Bradley Heights Apartments

A 236-Unit Apartment Development Puyallup, Washington

Bradley Heights SS LLC

(Construction Set, Sheet A2, Site Plan)

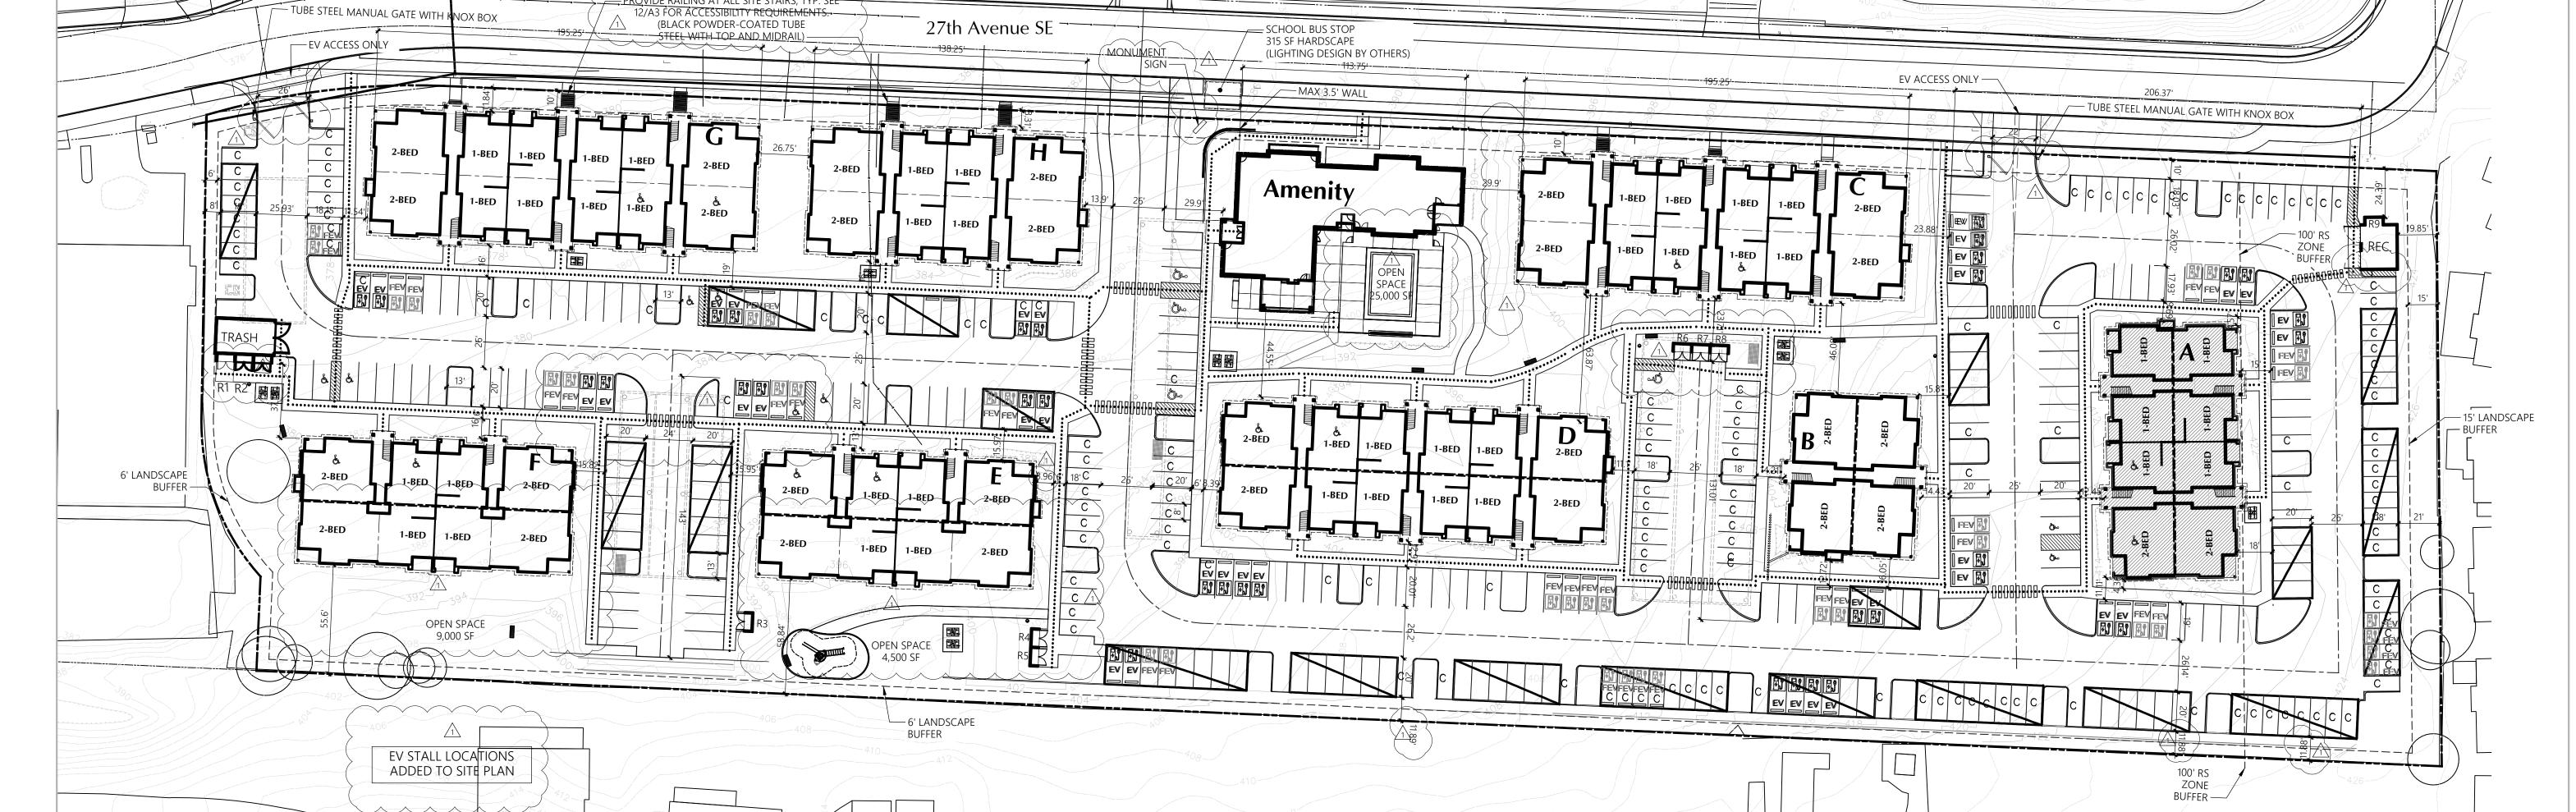
Provide a definition of "future electric vehicle charging stall infrastructure" as listed on the Site Key.

R1

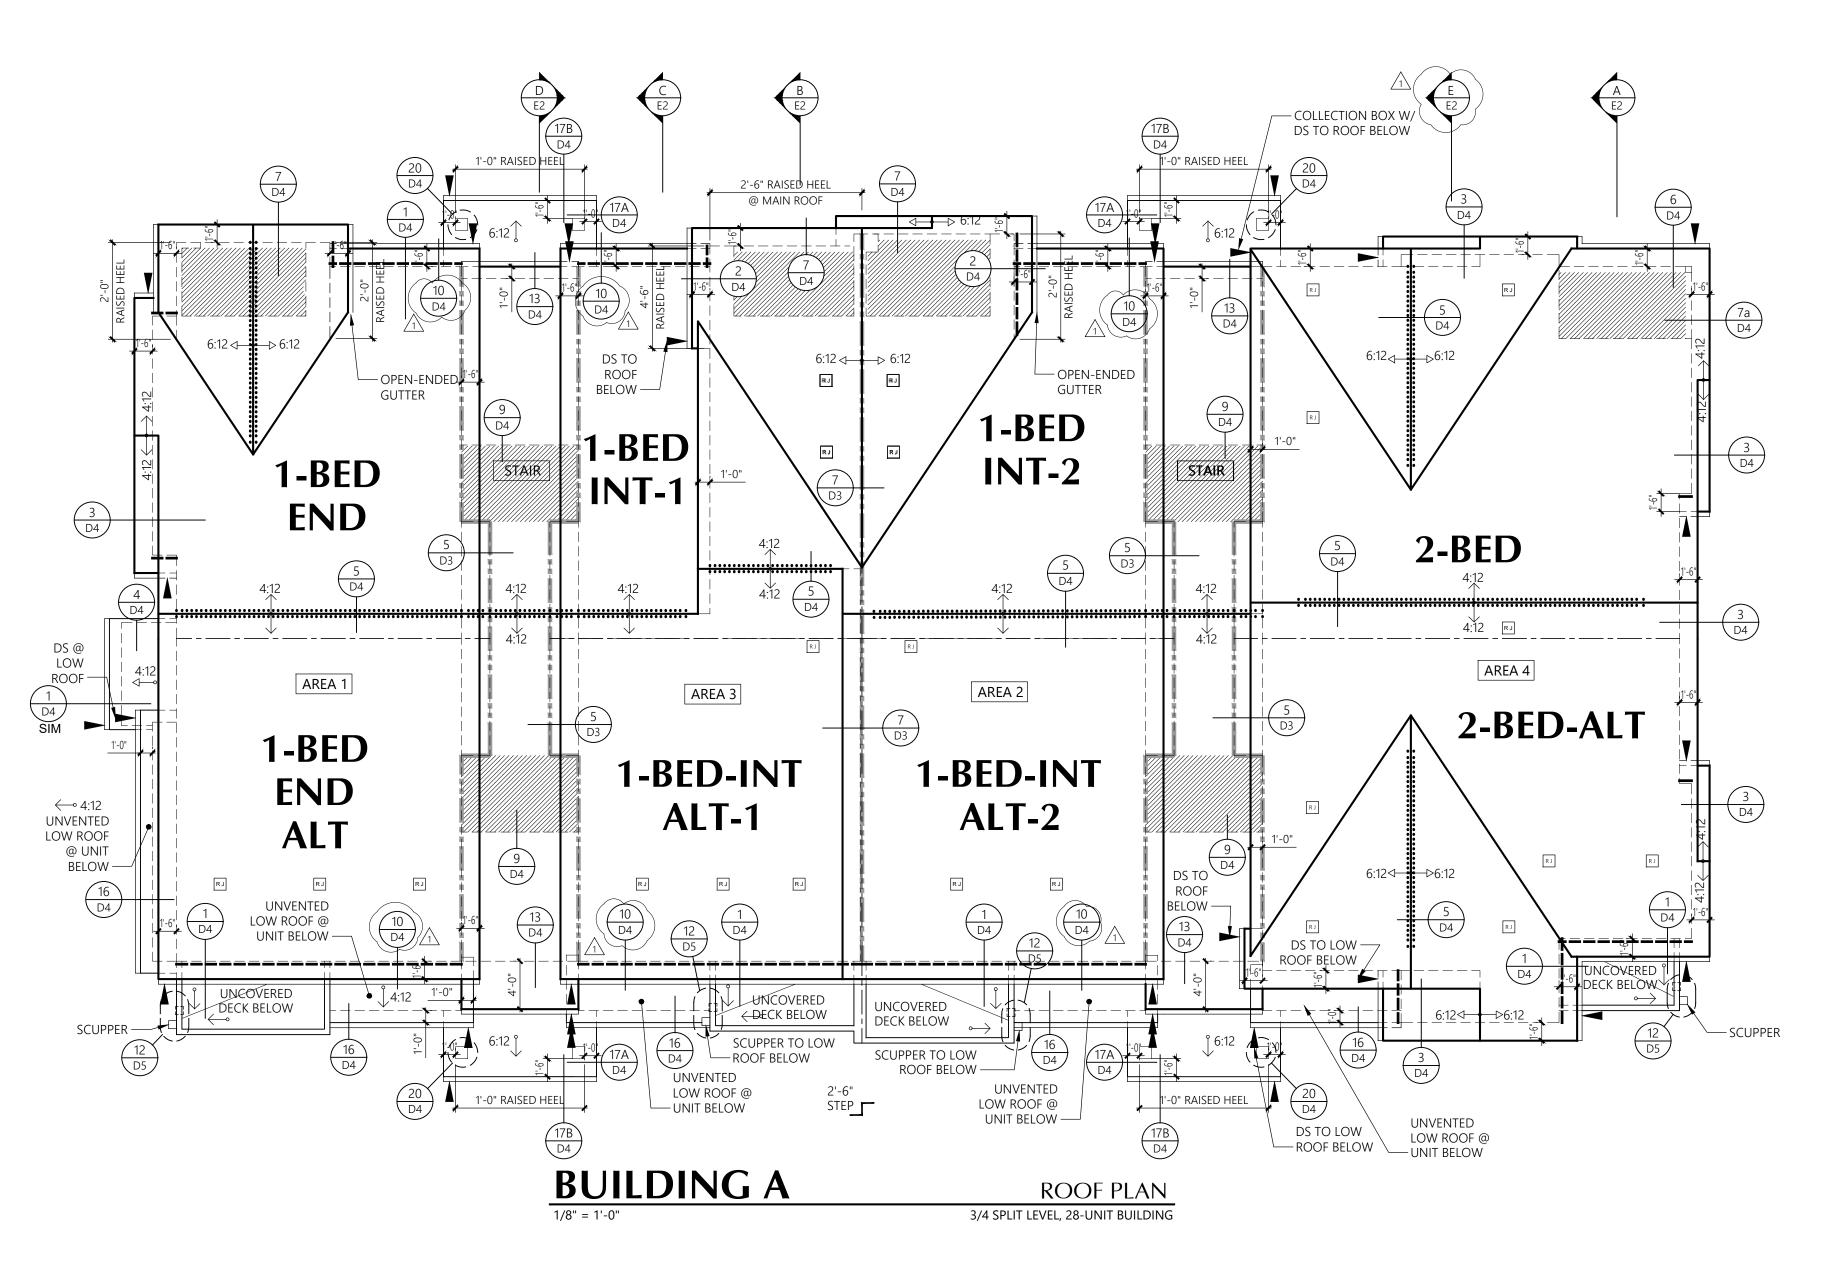
(Construction Set, Sheet R1, Unit Plans)
